**City of Chehalis Hearing Examiner
Staff Report for CU-21-002, ST-21-0011
April 14, 2022**

To: Hearing Examiner From: Amelia Schwartz, City Planner Date of Staff Report: April 7, 2022 Notice of Public Hearing: Issued March 31, 2022	Subject: Multiple-Unit Dwellings Zoning: R1 (Current), MRC (Proposed) Location: 1137 Washington Ave Date of Public Hearing: April 14, 2022. 4:00 PM Location of Hearing: City of Chehalis Council Chambers.
---	---

Current parcel locations and numbers as of April 7, 2022.

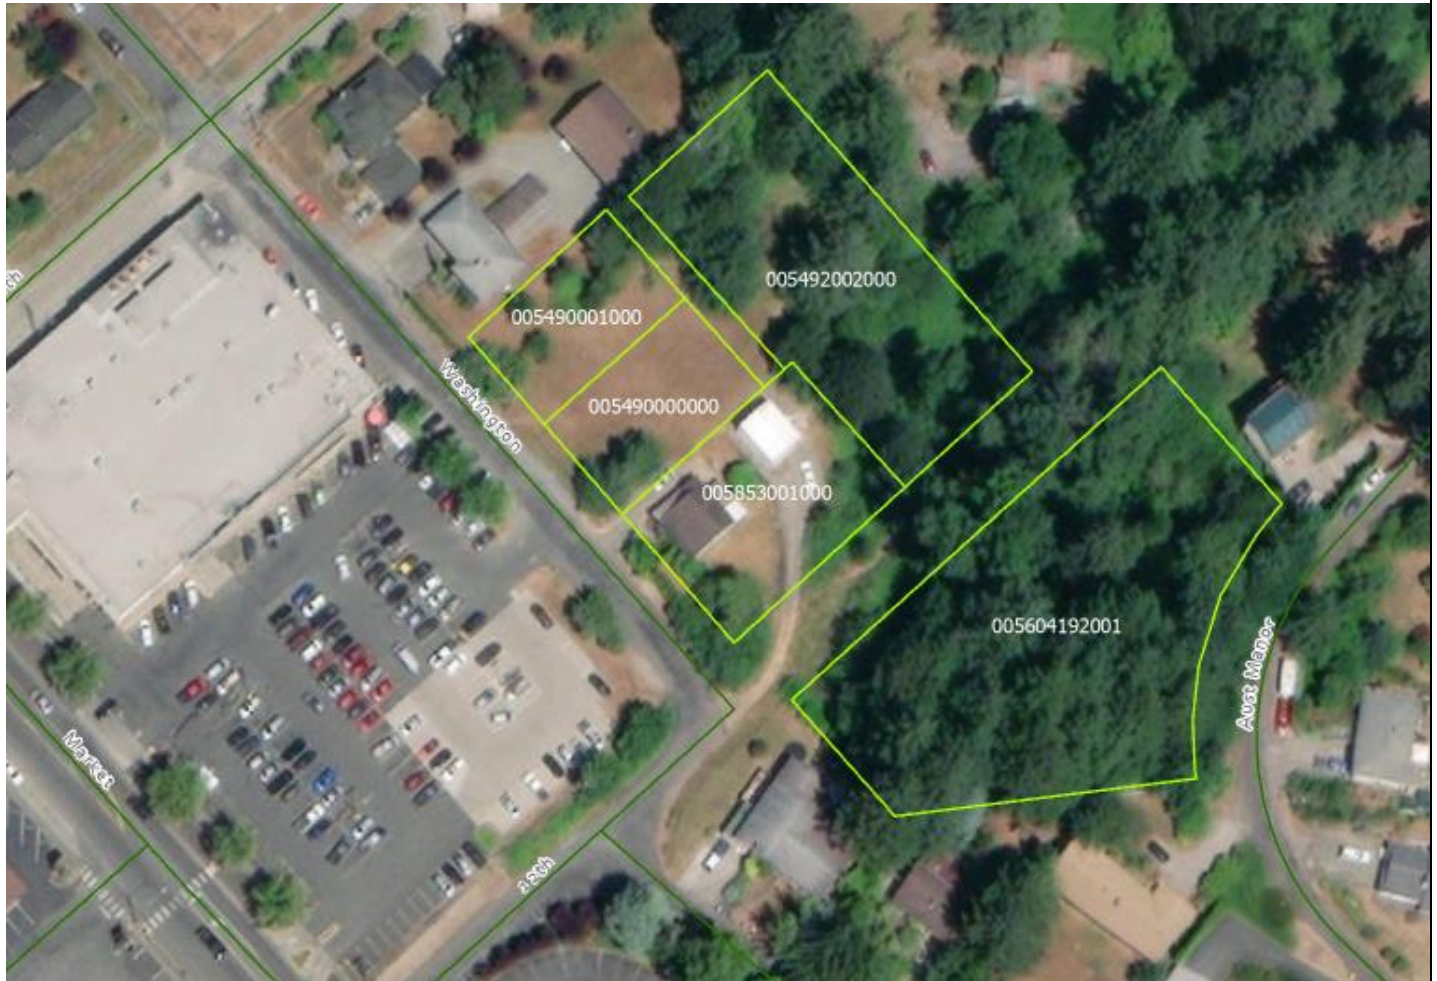
According to Lewis County GIS, much of the site contains hydric soils and is listed as susceptible to liquefaction, and according to nearby residents some portions experience pooling of water during heavy rains.
